Product: AAV2-hRPE65v2 (Spark scientific name), voretigene neparvovec - rzy1 (nonproprietary name), Luxturna (proprietary name)

Reviewer: Rabia Ballica, PhD, CBER/OCBQ/DMPQ/ MBR1

Subject: DMPQ Review Memo for Biological License Application (BLA) - submitted electronically May 16, 2017
ADD (PDUFA): January 14, 2018
Target approval date: December 19, 2017

Figure 2. Manufacturing process and microbial content controls

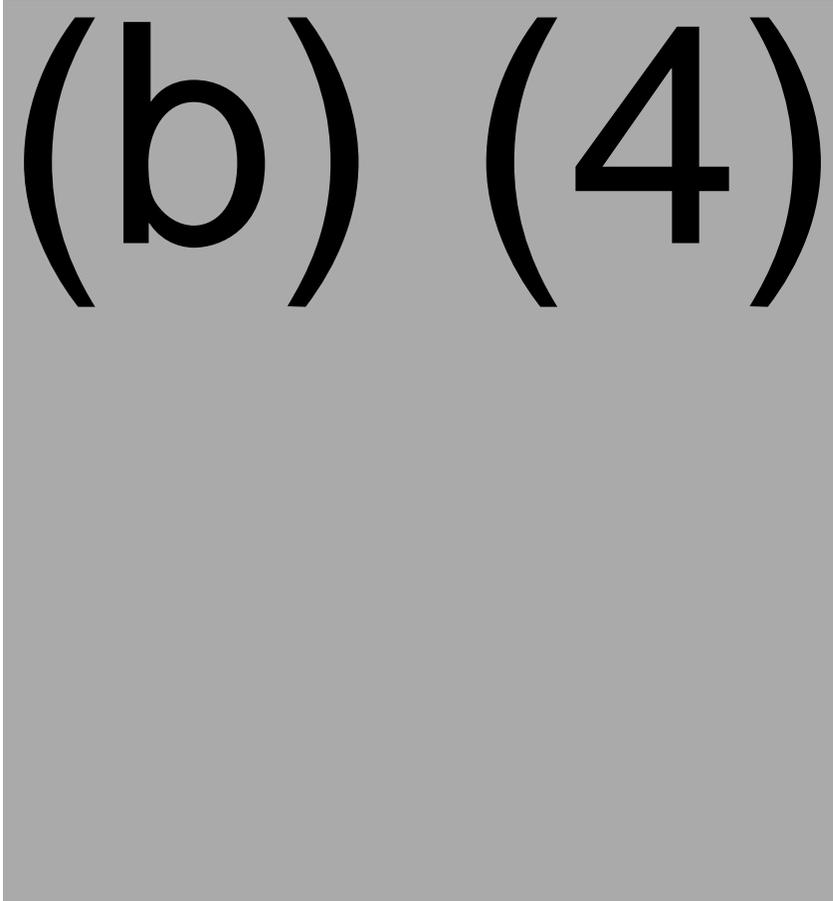
Comment: Note that the PPQ lot (refer to PPQ batch analysis below) will not be distributed. During the PLI of Spark DS manufacturing facility, there was ongoing DS manufacturing campaign for voretigene neparvovec -rzyl.

Table 1 describes the cleaning frequency for the Biosafety Cabinets (BSCs), the (b) (4) areas.

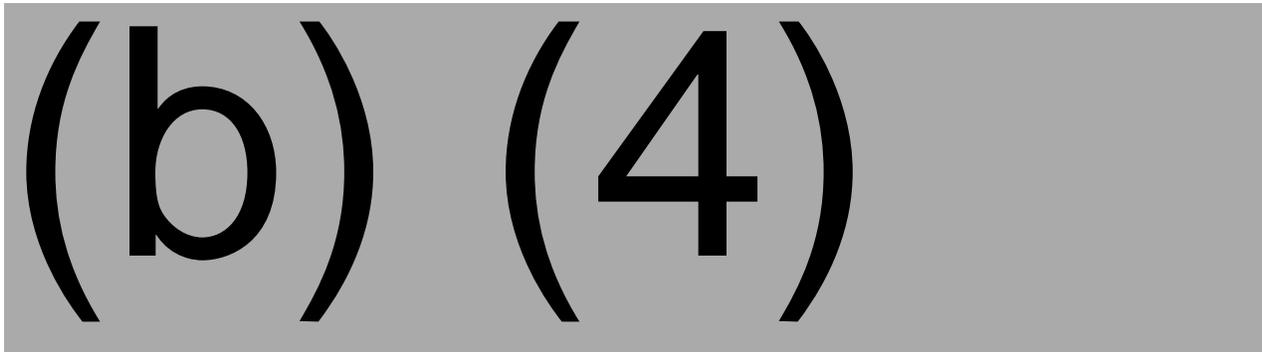
2.4. Please provide cleaning frequency for BCSs and (b) (4) areas.

Reviewer Comment: Acceptable. Note that changeover and cleaning procedures were evaluated during the PLI (refer to EIR).

Table 1. Equipment for Use in Filling (b) (4)

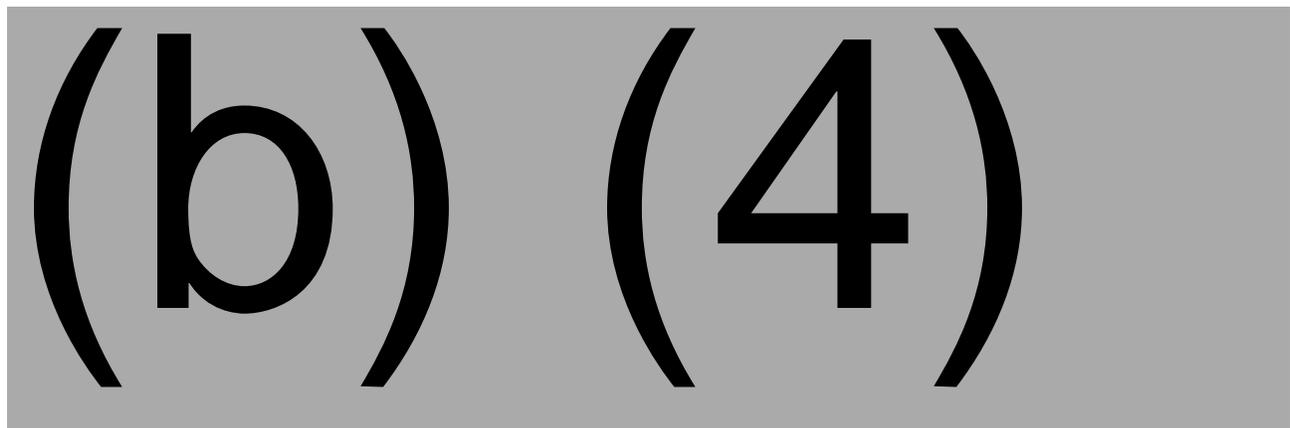
2.1. Please provide a detailed description of the equipment present in (b) (4) during voretigene neparovec drug product and diluent filling (in Filling Suite (b) (4)).

Reviewer Comment: *Addressed.*

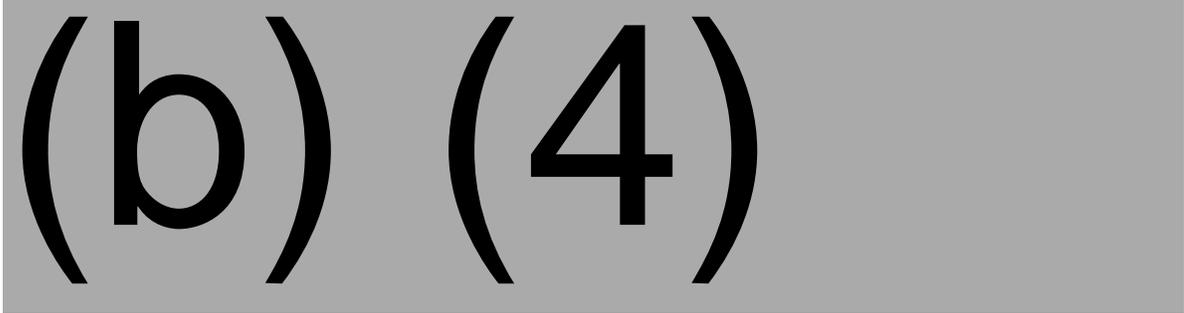
4. We note from the information provided in your August 22nd Amendment that a sterilization validation report is provided for (b) (4) of 20mm stoppers. Please provide a justification/rationale for not providing a validation report specific for 13 mm (b) (4) stoppers used for voretigene neparvovec drug product and the diluent.

Reviewer Comment: *Acceptable, because the validation based on the size and type of (b) (4) box. Note that the type and size of the (b) (4) box packed with 20mm stoppers are the same as those of the box packed with 13mm stoppers. The stoppers are packaged in small cardboard boxes ((b) (4)).*

(b) (4) *Media Fill Particle Count Data* (b) (4) :

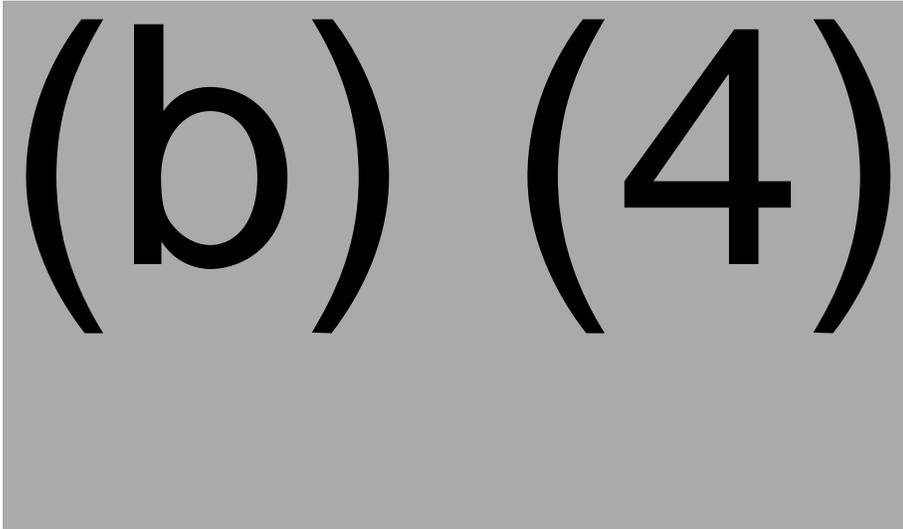
1. Please provide data (results of EM and media fill) from the media fill run being executed September 26 through October 10, 2017. Please ensure that non-viable particle monitoring in operation (as you agreed in the e-mails dated August 29 - August 31, 2017) will be performed during this media fill run.

Reviewer Comment 1: EM and media fill results are acceptable, except for the results of non-viable particle monitoring in operation. Refer to the OCBO assessment for the results of non-viable particle monitoring in operation below.

Reviewer Comment 2 (on results of continuous non-viable particle monitoring):
Acceptable based on the OCBQ assessment and the results of particulate matter testing at release and during the DP filling (refer to Tables 24 and 25 in this memo).
